NAPA VALLEY TRANSPORTATION AUTHORITY

Board Agenda Letter

TO: NVRTA Board of Directors
FROM: Kate Miller, Executive Director
REPORT BY: Danielle Schmitz, Director – Programs, Projects, and Planning
(707) 253-5968 / Email: dschmitz@nvta.ca.gov
SUBJECT: Approval of the State Route 37 (SR 3 Transportation and Sea Level Rise Corridor Improvement Plan

SR 37 Corridor Plan Appendix D - Response to Comments				
ID	Comment Origin	Name	Comment	Response
1	Napa Workshop		Suggests further consideration of public transit options, especially bus service.	There is a north bay transit operators group that meets quarterly that the CMAs participate in; the CMAs and transit operators are also in discussion about a origin/destination study to identify home and work destination sites for users of the corridor to see if transit would be feasible. There are also TDM strategies that could be implemented on the corridor, such as vanpools.
2	Napa Workshop		Supports preserving the function of wetlands, creating HOV lanes and an expanded ferry service between Vallejo and Marin.	MTC, the north bay CMAs and Caltrans are working with the environmental community to develop design options integrating transportati

Exhibit 5: Weak Links Assessment

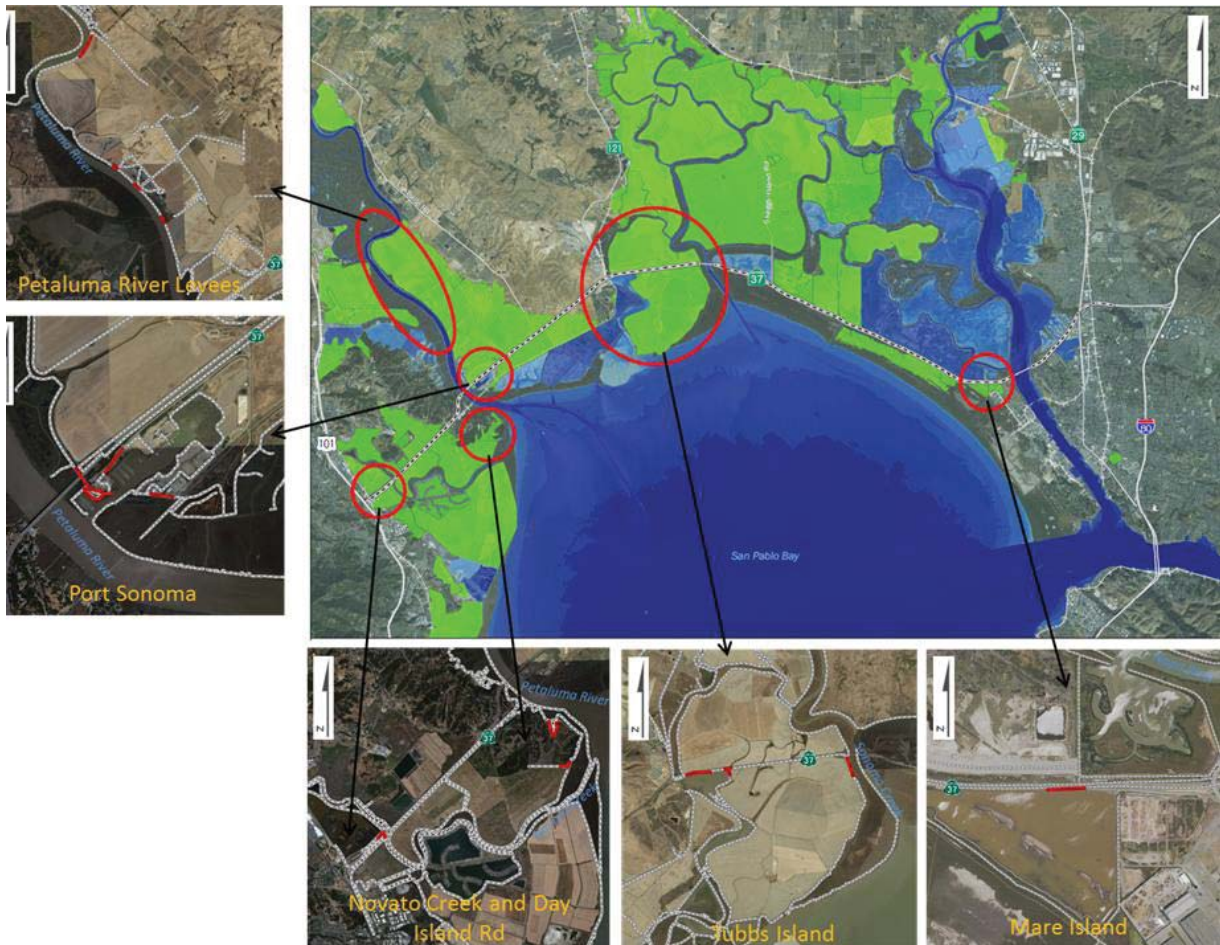
45	DAA Public Comment	Marin County, Department of Public Works	Page 7 - Exhibit 5 is difficult to read and to pull out the information about where exactly the weak links are.	Comment noted. Exhibit 5 is intended to show the general locations of the weak links.
46	DAA Public Comment	Marin County, Department of Public Works	Page 14 - Traffic is also displaced to Atherton Avenue when SR 37 is closed at Novato Creek. There is no capacity on that two lane road for SR 37 traffic.	Comment noted.
47	DAA Public Comment	Marin County, Department of Public Works	Page 16 - Exhibit 15. Sears Point/Infineon Raceway is north of SR 37; on this map the marker is south. And the train segment should be labeled Amtrak only (not Capital Corridor).	Graphic will be updated as appropriate.
48	DAA Public Comment	Marin County, Department of Public Works	Page 17 -Please provide details for costs shown in Table 2.	Preliminary cost estimates were included in the corridor plan, and may be refined in later project phases.

Exhibit 16: Schematics of representative Intersection operation improvements and lane merge improvements

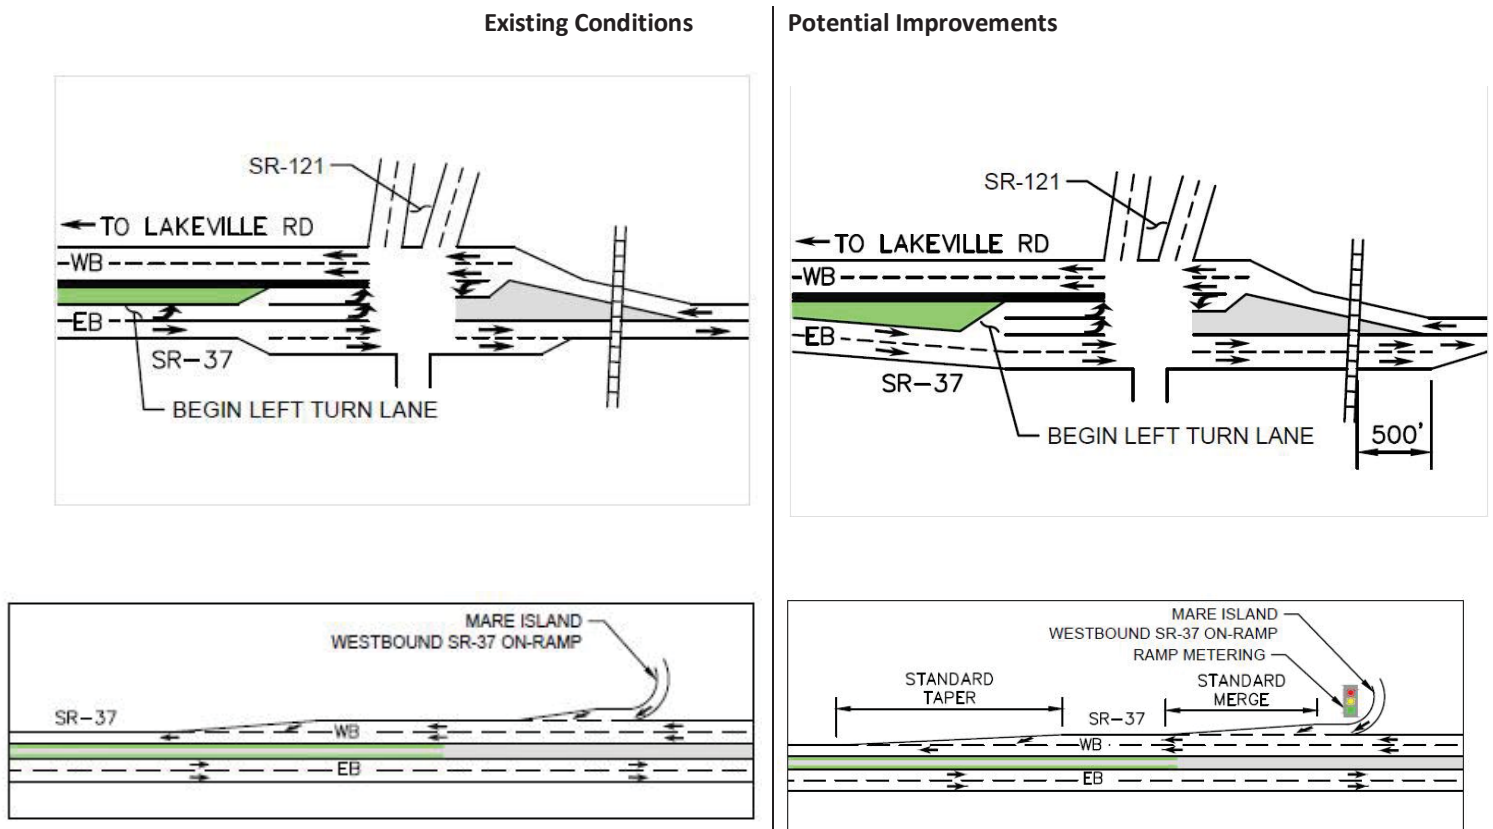
90	DAA Public Comment	Sonoma County Transportation and Land Use Coalition	Page 17, Maintain Existing Roadway. Revise to call for improvement of the existing roadway in the next two or three years. In addition to the suggested lane modifications, features such as diamond lanes, lane-metering, and queue-jumping options should be evaluated to encourage use of carpools, van-pools, and to enable establishment of bus routes through the corridor.	These ideas, including TDM strategies, will be evaluated. Request for queue-jumping options will be passed on to Caltrans and evaluated as projects are identified and advanced.
91	DAA Public Comment	Sonoma County Transportation and Land Use Coalition	Page 19, Raised Roadway. Revise to describe the current state of knowledge about the depth of bedrock along SR-37. Feasibility of the various options depends greatly on foundation conditions and on forecasts of mud compaction beneath berms. It may not be possible to proceed much further with planning until more geological information is available.	Geotechnical investigation will be part of future studies.

Exhibit 21: Existing Condition

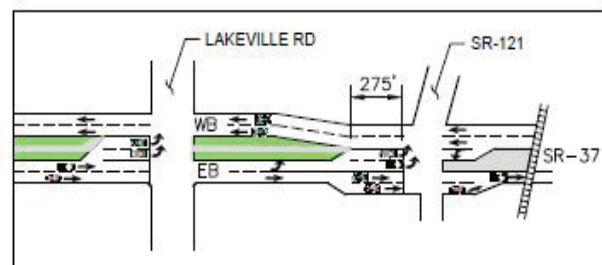
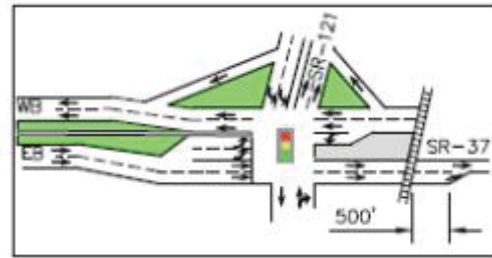
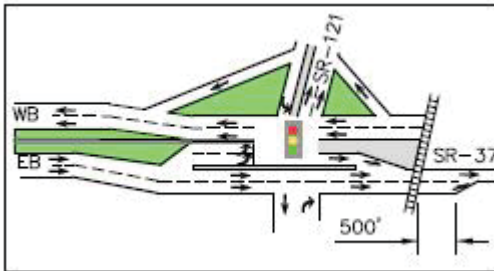
98	DAA Public Comment	Sonoma County Regional Parks	Near-term options for the SR121-SR37 intersection (pages 22-23) do not address bicycle and pedestrian facilities or connections to the Bay Trail.	Comment noted.
99	DAA Public Comment	Sonoma County Regional Parks	The "Potential Improvements" on Exhibit 16 (page 1 7) shows a proposal to increase the length of the eastbound right lane. The increased lane length would require widening of SR3 7 and could reduce the amount of land available to develop a proposed trailhead parking lot for the Bay Trail. Regional Parks is evaluating a trailhead parking lot at the southwest intersection of SR37 and railroad tracks.	Comment noted.
100	DAA Public Comment	Sonoma County Regional Parks	Many of the concepts (pages 25-26) indicate use of a Class IV bikeway along the reconstructed SR37. Class IV bikeway is intended for the exclusive use by bicyclists and no pedestrians. These options would require construction of a separate exclusive facility for pedestrian use that is not currently indicated. Some of the options being considered in the Bay Trail - Sears Point Connector Feasibility Study, such as an elevated boardwalk or floating boardwalk crossing of Tolay Lagoon may be compatible with SR37 vehicle options and would provide a separate pedestrian and bicycle facility. We recommend at a minimum a Class I bicycle path with a physical barrier separating vehicle traffic on the south side of the roadway facing San Pablo Bay. This will allow trail users to enjoy and experience the views of San Pablo Bay and beyond.	The alternative included in the document are preliminary and include possible options for accommodating bicycles with roadway widening. They are not intended to preclude other alternatives that may be explored during later project development phases.
